SEQWATER DAMS

WIVENHOE DAM COMPREHENSIVE INSPECTION JULY 2006

SURVEILLANCE REPORT **FINAL REPORT**

Report No: DC07063

Figure 4-1 - ANCOLD Total Societal Risk Assessment – from Wivenhoe Alliance, 2004

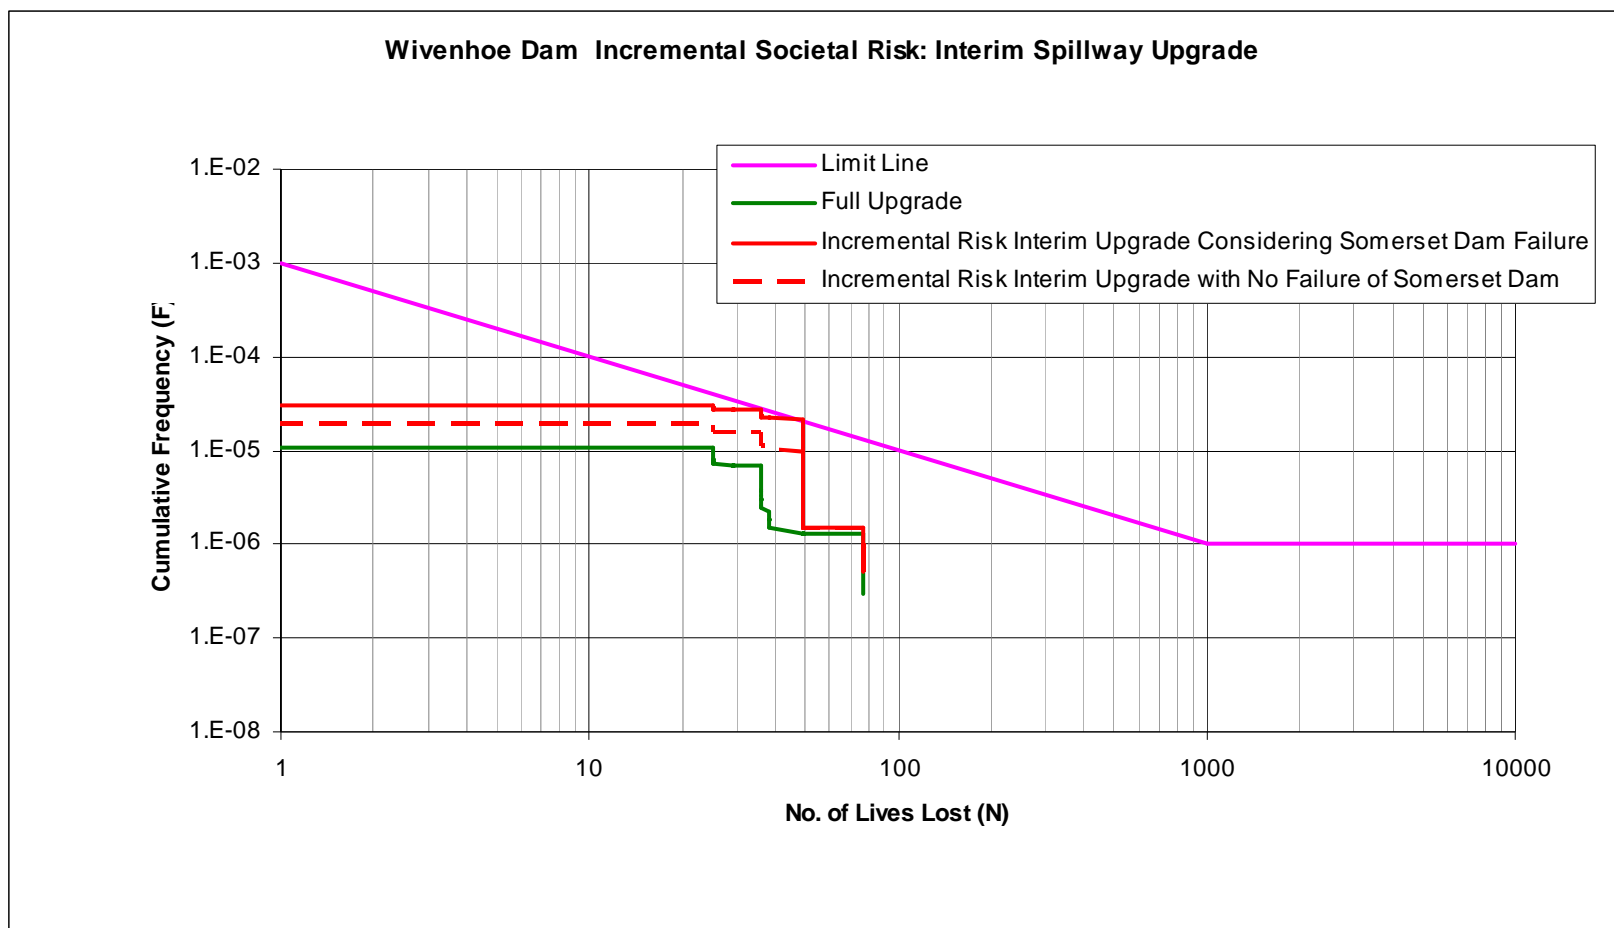
The Wivenhoe Alliance further revised this work to incorporate the risks associated with a Somerset failure. The FN Charts for total loss of life is shown at Figure 4-1 and indicates that:
